UNITED STATES PATENT AND TRADEMARK OFFICE

APPLICATION NO.	FILING DATE	FIRST NAMED INVENTOR	ATTORNEY DOCKET NO.	CONFIRMATION NO.
10/585,740	07/12/2006	Byeong-Ju Park	0630-2786PUS1	7844

Office Action Summary	Application No. 10/585,740	Applicant(s) PARK ET AL.	
	Examiner MINH D. A	Art Unit 2821

DETAILED ACTION

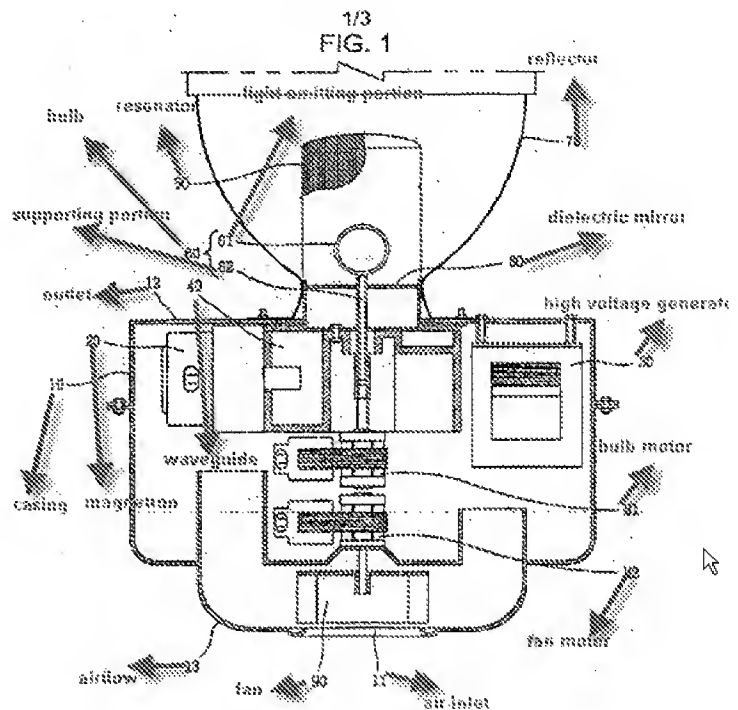
3. Claims 1, 3, 5, 7-9, 11, 13-19 are rejected under 35 U.S.C. 103(a) as being unpatentable over by Applicant Admitted Prior Art (AAPA) discloses in figure 1, in view of Zimmerling et al (Pub. No: U.S 2005/0062567A1).

Regarding claim 1, AAPA discloses in figure 1 that, an apparatus for preventing leakage of a material inside a bulb (60) for a plasma lighting system, comprising: a bulb (60) containing a discharge material therein for emitting light as the discharge material becomes a plasma state by an electric field (emitting portion (61) with electric field and discharge material on the bulb(60); AAPA also discloses that, an external electric field of the bulb at a peripheral portion as shown in figure 1.

However, AAPA does not disclose that, wherein the magnetic field forming portion forms a magnetic field as a wedge shape so that the electric discharge material

Regarding claim 5, combination AAPA and Zimmerling disclose all limitations as recited in claim 1 and figure 1 above that, an apparatus for preventing leakage of a material inside a bulb for a plasma lighting system, comprising: a resonator (50); a bulb(60) received in the resonator(50) and containing a discharge material therein for emitting light(61) as the discharge material becomes a plasma state by an electric field; and a magnetic field forming portion for preventing the discharge material of a plasma state from being leaked by an external electric field of the bulb by forming a magnetic field at a peripheral portion of the bulb; wherein the magnetic field forming portion forms a magnetic field as a wedge shape so that the electric discharge material is positioned at a center of the bulb.

FIG. 3

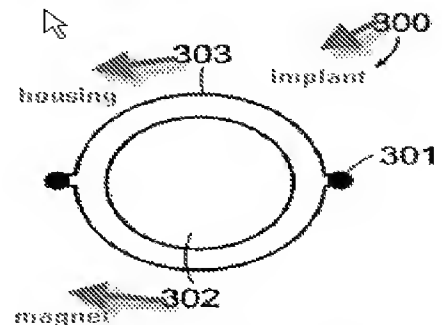
Zimmerling et al disclose, in figure 3 that, an implantable magnet (302) for apply magnet field and can be used to prevent leakage of material into the body of the implant (300).

Paragraph [0048], lines 4-11 and selecting or using any shape for magnet as shown in paragraph [0050], lines 1-3.

It would have been obvious to one having ordinary skill in the art to employ the magnet and the difference shape of magnet of Zimmerling et al into the bulb plasma lighting system of AAPA to achieve the claimed invention. As disclosed in Zimmerling et al, the motivation for the combination would be to prevent the leakage of a material inside the bulb for a plasma lighting system.(See the magnet for prevent leakage of material as shown in paragraph[0050], lines 1-3.

**FIG. 3**

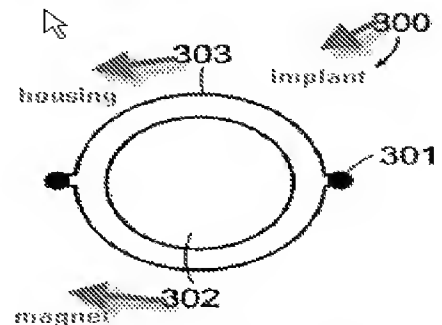
Zimmerling et al disclose, in figure 3 that, an implantable magnet (302) for apply magnet field and can be used to prevent leakage of material into the body of the implant (300) and the magnet(302) can be any shape. Paragraph [0047], lines 4-7 and paragraph [0048], lines 4-10 and Paragraph [0050], lines 1-4.

It would have been obvious to one having ordinary skill in the art to employ the magnet of Zimmerling et al into the bulb plasma lighting system of AAPA to achieve the claimed invention. As disclosed in Zimmerling et al, the motivation for the combination would be to prevent the leakage of a material inside the bulb for a plasma lighting system.

FIG. 3

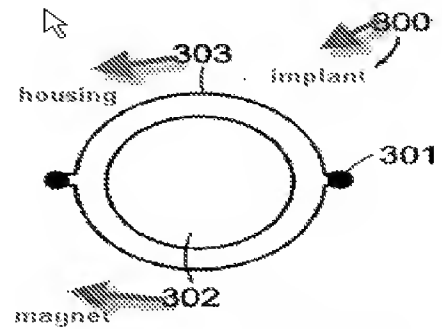
Applicants' argument in each independent claims 1, 5 and 11 that, there is no disclose or made obvious by the prior art of record "wherein the magnetic field forming portion forms a magnetic field as a wedge shape so that the electric discharge material

The examiner disagrees, Prior Art (AAPA) and Zimmerling et al (Pub. No: U.S 2005/0062567A1) disclose all of this limitation, specifically, Zimmerling et al disclose in figure 3 above that, an implantable magnet (302) for apply magnet field and can be used to prevent leakage of material into the body of the implant (300) as shown in paragraph [0048], lines 4-11 and selecting or using any shape for magnet as shown in paragraph [0050], lines 1-3.

Therefore, one with ordinary skill in the art would have been motivated at the time the invention was made to have combined the plasma lighting system of AAPA includes the magnet (302) with any shape of Zimmerling et al, since at the time the invention was made there was need to provide the magnet into the plasma lighting system to prevent leakage of material.
